UNITED STATES PATENT AND TRADEMARK OFFICE

APPLICATION NO.	FILING DATE	FIRST NAMED INVENTOR	ATTORNEY DOCKET NO.	CONFIRMATION NO.
10/672,922	09/26/2003	Alex Ezra Cable	9314.0027	9462

Office Action Summary	Application No. 10/672,922	Applicant(s) CABLE ET AL.	
	Examiner Vinh T. Luong	Art Unit 3682

ATTACHMENT

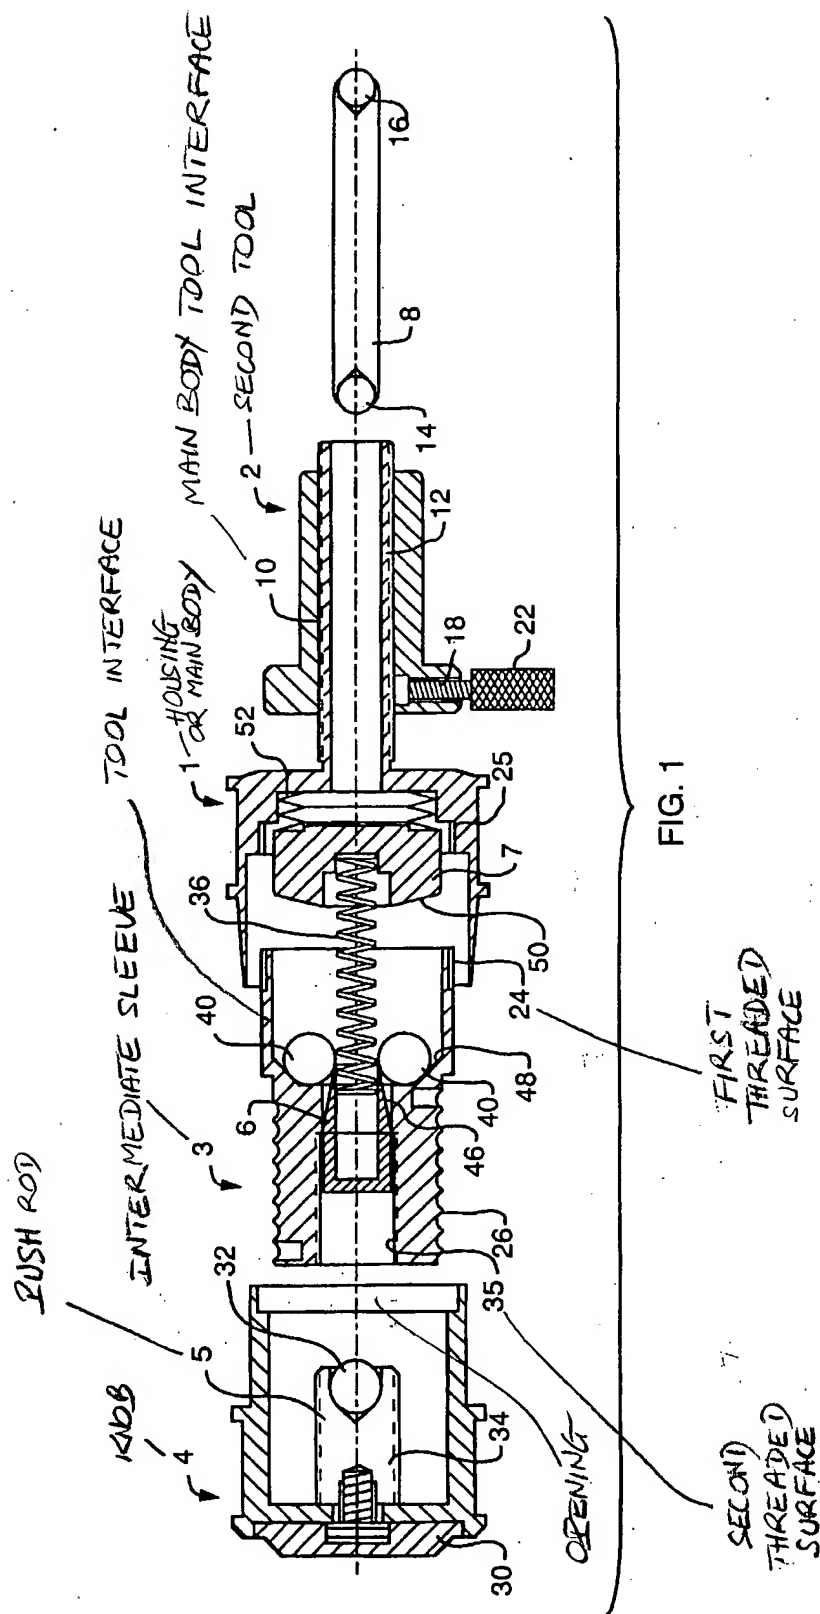
Regarding Claim 1, Cable teaches a differential adjuster, comprising: an intermediate actuator sleeve 3 with a first threaded surface 24 *operatively* engaging a housing 1 to adjust the position of the intermediate actuator sleeve 3, a second threaded surface 35 *operatively* engaging a push rod 5 to adjust the position of the intermediate actuator sleeve 3 relative to the push rod 5, and a tool interface (at 48 in FIG. 1, see Attachment hereinafter "Att.").

Regarding Claim 17, see a knob 4 *operatively* coupled to the main body 1 to provide a coarse adjustment, the knob 4 defining an opening (Att.) allowing access to the tool interface.

Regarding Claim 41, the intermediate actuator sleeve 3 includes a tool interface (at 48 in FIG. 1, see Att.).

Regarding Claim 42, the tool interface (Att.) of the intermediate actuator sleeve 3 is capable of accommodating an adjustment tool, the adjustment tool chosen from the group consisting of a spanner wrench, a socket, a screw driver, a ball driver, and an Allen wrench. Moreover, note that referring the differential adjuster to the merely inferentially included element or intended use element, such as, the tool that engages the tool interface of the intermediate actuator sleeve is not accorded patentable weight.

FIG. 2

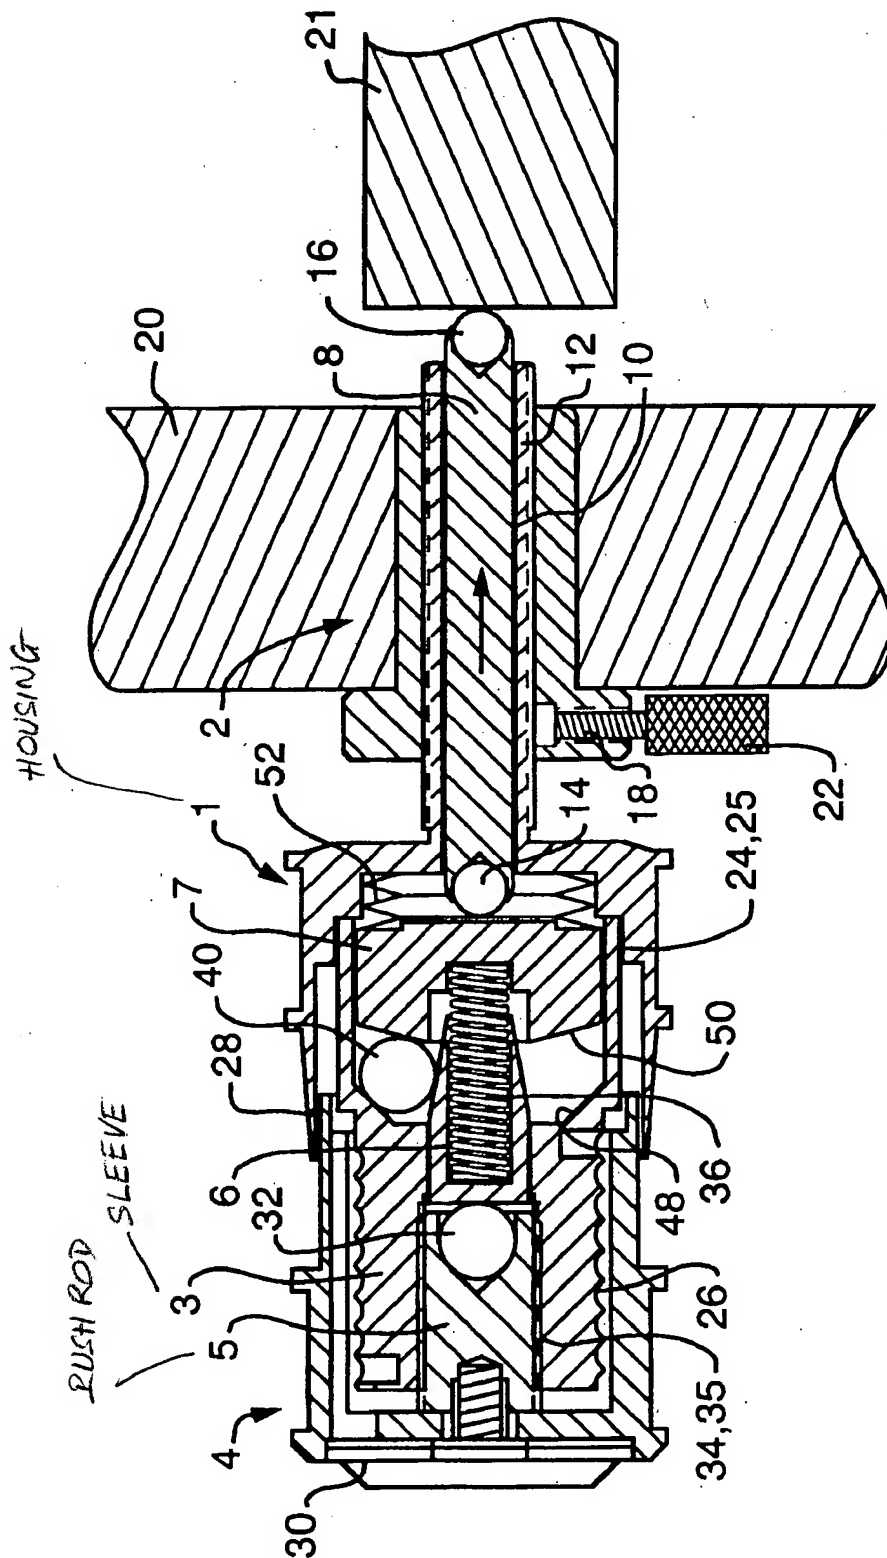
Regarding Claim 3, the housing 1 and the push rod 5 are arranged so that the push rod 5 is capable of being rotationally constrained with respect to the housing 1. See FIGS. 2 and 3.

Regarding Claim 7, Cable's first threaded surface 24 is equivalent to the internal threaded surface 25 (FIG. 2) and Cable's second threaded surface 35 is equivalent to the external threaded surface 26. See MPEP 2144.06 *supra*.

Regarding Claim 25, the housing 1 is a component mount or positioner that engages the first threaded surface 24 of the intermediate actuator sleeve 3 (FIGS. 2 and 3).

The Applicant respectfully submits that common knowledge based on standard physics text books teaches that the relative rotation between Cable's push rod 5 and body 1 is inherently restricted by the frictional force resulting from the motions of the ball detent 40, spring 6, and tapered pin 6, *etc.* as seen in FIG. 2.
